Re: Ivanpah Solar Electric Generating Systems (Ivanpah SEGS)
 Final Memorandum - AECOM Stormwater Modeling Review

TECHNICAL MEMORANDUM

Date: July 2, 2009
To: Bob Dover (AECOM)
From: Serkan Mahmutoglu (AECOM)
Subject: Stormwater Runoff and Sediment Transport Sensitivity Analysis- Ivanpah Solar Electric Generating System (ISEGS)

Figure 1. Floodplain Velocity (Existing and Proposed)

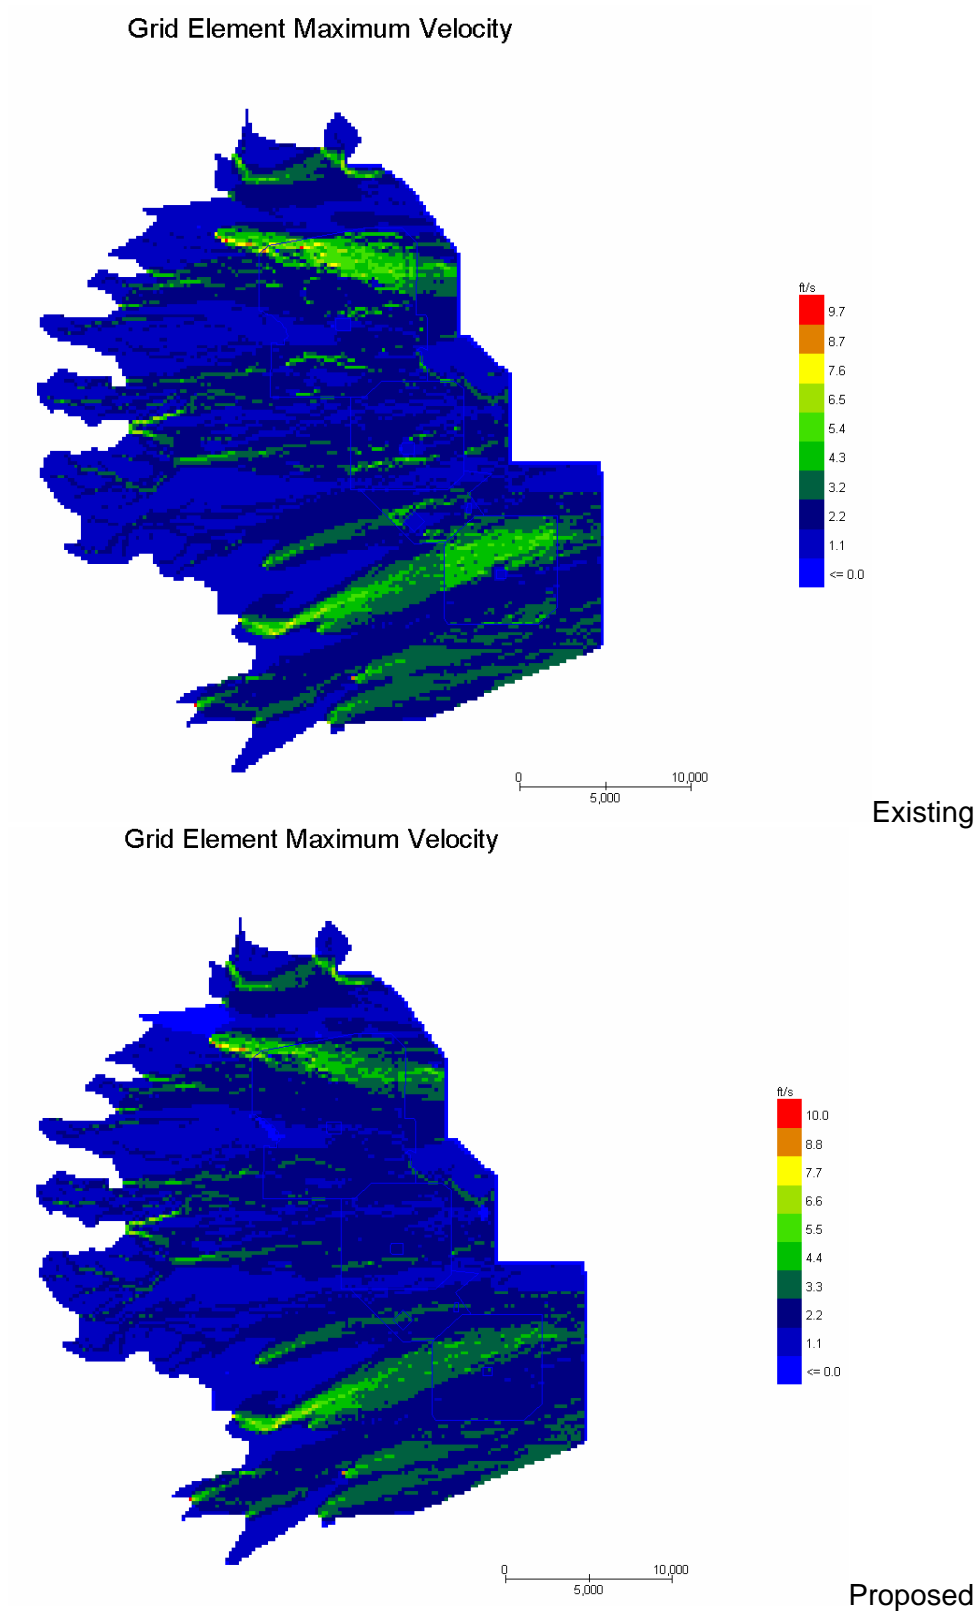
Figure 1 and Figure 2 show the existing and proposed conditions floodplain velocity and floodplain flow depth, and Figure 3 and Figure 4 show the existing and proposed conditions floodplain flow depth, respectively. Figure 3 and Figure 4 show the change in velocity and depth, respectively. Positive numbers indicate an increase in velocity or depth due to proposed conditions.

The results of this conservative analysis suggest that further consideration will be necessary for stormwater runoff protection. In the event of a 100-year storm the Ivanpah Solar Energy System would suffer significant damage as designed causing significant environmental impact potential.

Figure 5. Floodplain Velocity (Existing and Proposed)

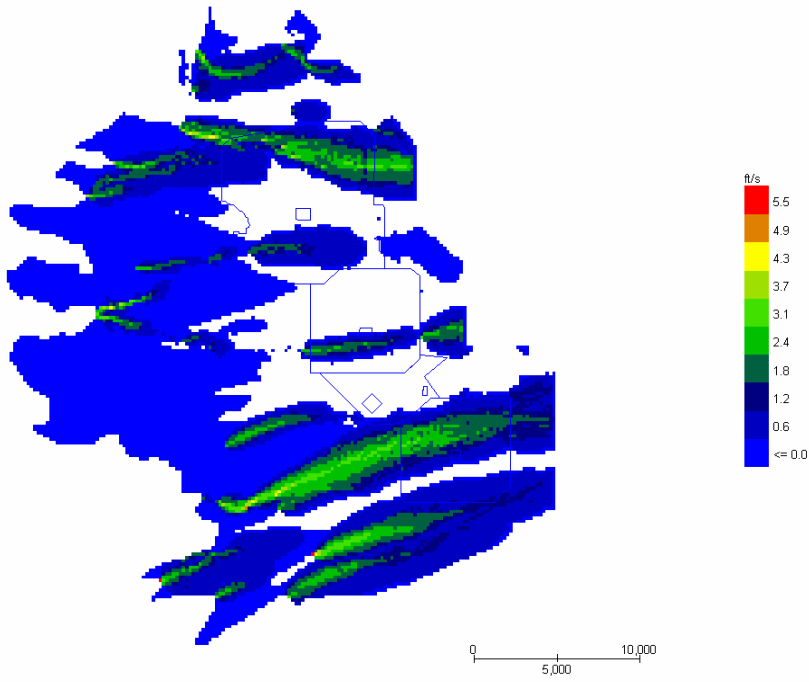
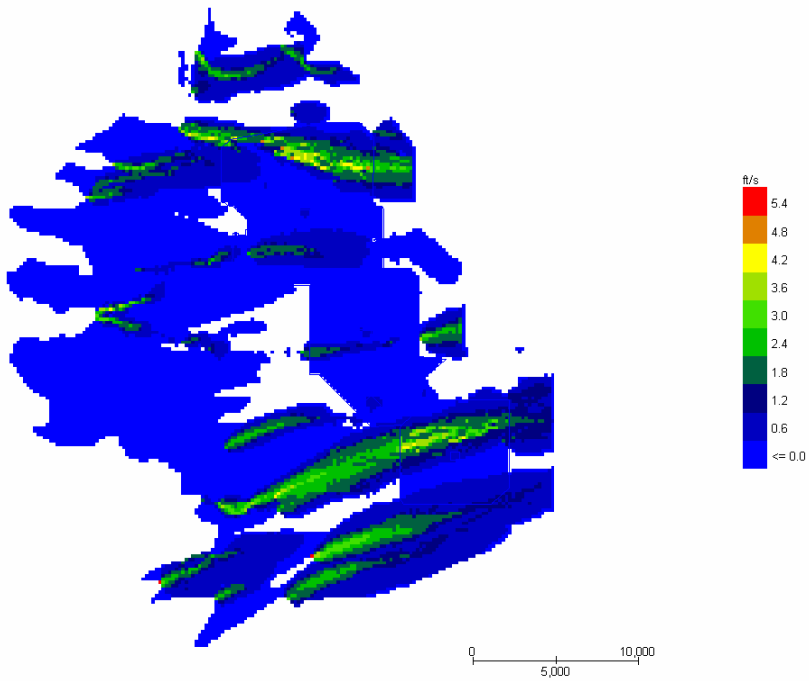
The impact on runoff is shown in Table 9, local scour at heliostats are shown in Table 10, floodplain velocities are shown in Figure 5, floodplain flow depths are shown in Figure 6, change in velocity on the floodplain is shown in Figure 7, and change in flow depth is shown in Figure 8.
